Re: French Creek West, Preliminary/Final
Subdivision and Land Development Plan – 3rd Review

Project Scope: 551 Dwelling units, public parking lot
Applicant/Owner: French Creek TH, LP
Property Address: French Creek West
Parcel Numbers:

- Review Response Letter dated 7-25-2019
- French Creek West Preliminary/Final Plan Set, 81 sheets (revision date 7-25-2019)

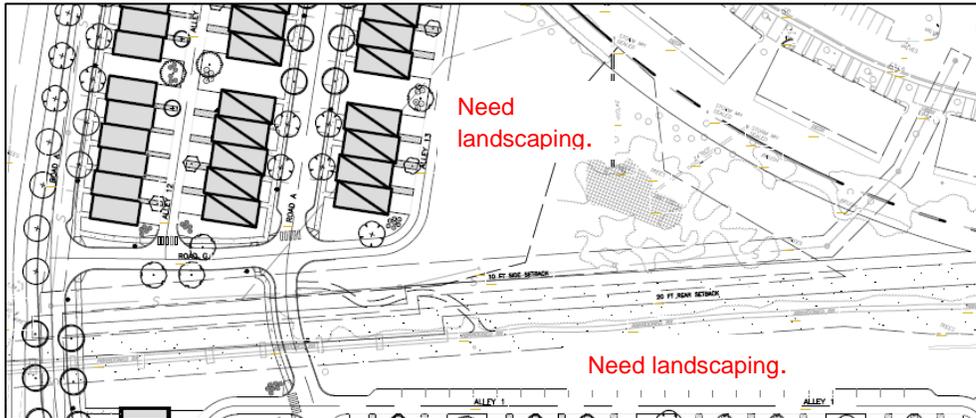
- a) Alleys. Additional landscaping could be provided along some of the single loaded, most notably Alley 1 and Alley 13. These areas are shown below.

This issue is resolved. Additional landscaping has been provided in these areas and the existing tree line/vegetation to be maintained is now shown.

Central Park

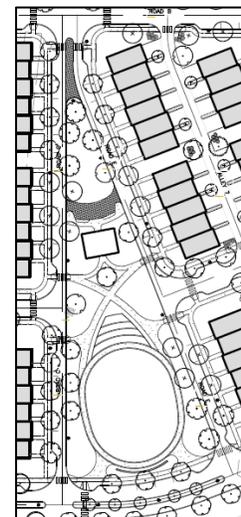
- c) Central Open Space. This area, which is shown in the image to the right, does not appear to have been fully designed at this point. Is additional landscaping and lighting proposed?

Resolved. This area is now fully designed.
